Figure 1 Minimum lot size with proposed 3 hectare area indicated

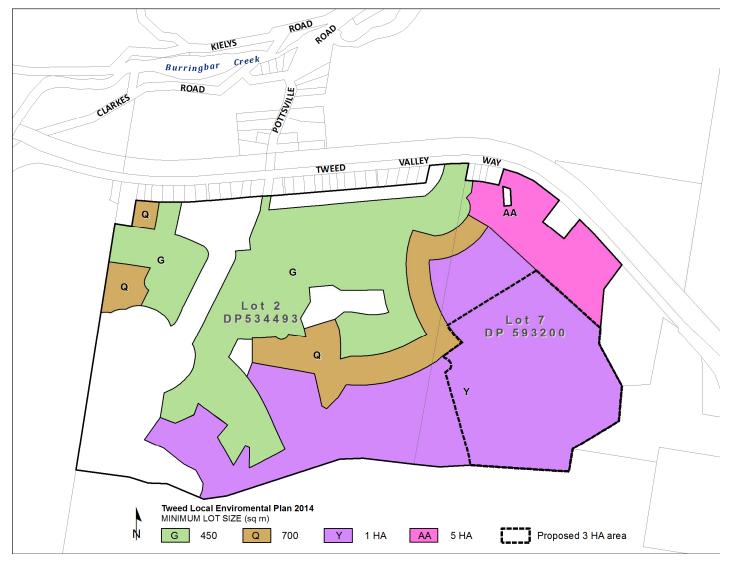
Recommendations: Adjust minimum lot size map by substituting area allocated for minimum 450m ² lots, with minimum 550m ² lots.
		Adjust minimum lot size map by substituting south eastern corner of the site allocated for minimum 1 ha lots, with minimum 3 ha lots.
Contaminated L	and	
22	 Submitters note that the location of the development was historically used for banana production that applied toxic pest control chemicals. They are concerned about the land being contaminated and earthworks for the development resulting in contaminated runoff and airborne contaminates. They are also concerned about the impact of contaminated land on the future residents of the development. Submitters do not feel the contaminated land testing has been sufficient nor wide spread enough. They note that existing assessments were based 	As per the NSW Government's 'A guide to preparing planning proposals' the intent of a Planning Proposal is to demonstrate the strategic merit of the proposal proceeding to the next stage of the plan-making process. The intent of the Planning Proposal is not to provide detailed design information. The Planning Guidelines 'Managing Land Contamination (Department of Urban Affairs and Planning, and Environmental Protection Authority (1998)) states four investigation stages in identifying and managing contaminated lands:

In conclusion, the information already provided is sufficient to determine development standards influenced by slope and stability (land zoning and minimum lot size). Adjustment of the south eastern corner of the site from 1 ha to 3 ha will allow development to respond to the characteristics of the site.
		Recommendation: Adjust minimum lot size map by substituting south eastern corner of the site allocated for minimum 1 ha lots (refer to Figure 1), with minimum 3 ha lots.
Earthworks		
15	 Submitters are concerned about the impact of earthworks required to raise the development by 12 m to be above the flood affected zone. They are concerned about the impact of the changed landscape on flooding, as well as the visual impact of the increased ground level, which they feel will be compounded by the height of buildings. 	Earthworks will be required for the development to be compliant with the provisions of the Tweed DCP Section A3 – Development of Flood Liable Land. A Flood Impact Assessment prepared by the proponent, following public
